THE COUNTY OF CHESTER

PLANNING COMMISSION

Re: Preliminary Land Development - Smith Property
Kennett Township - LD-05-19-15889

A preliminary land development plan entitled "Smith Property", prepared by DL Howell & Associates, Inc., and dated April 30, 2019, was received by this office on May 6, 2019. This plan is reviewed by the Chester County Planning Commission in accord with the provisions of Section 502 of the Pennsylvania Municipalities Planning Code. We offer the following comments on the proposed land development for your consideration.

Detail of sheet #2 of the plan

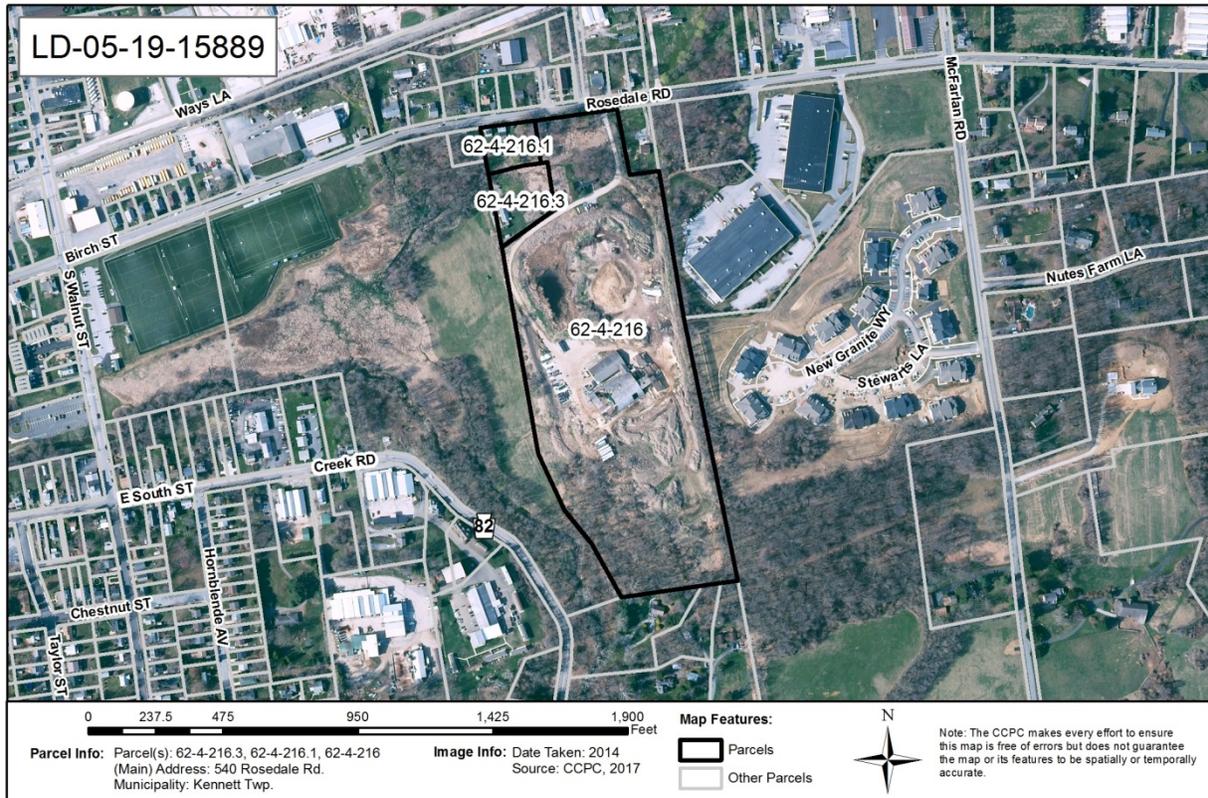
16. As suggested in our previous review the Township and the applicant should consider the need to accommodate rear decks. Many of the proposed units back directly onto the tract setback line, which would preclude the construction of decks unless a zoning variance was granted. The need for accessory storage structures should also be considered in the homeowners' document, and in the final land development plan.
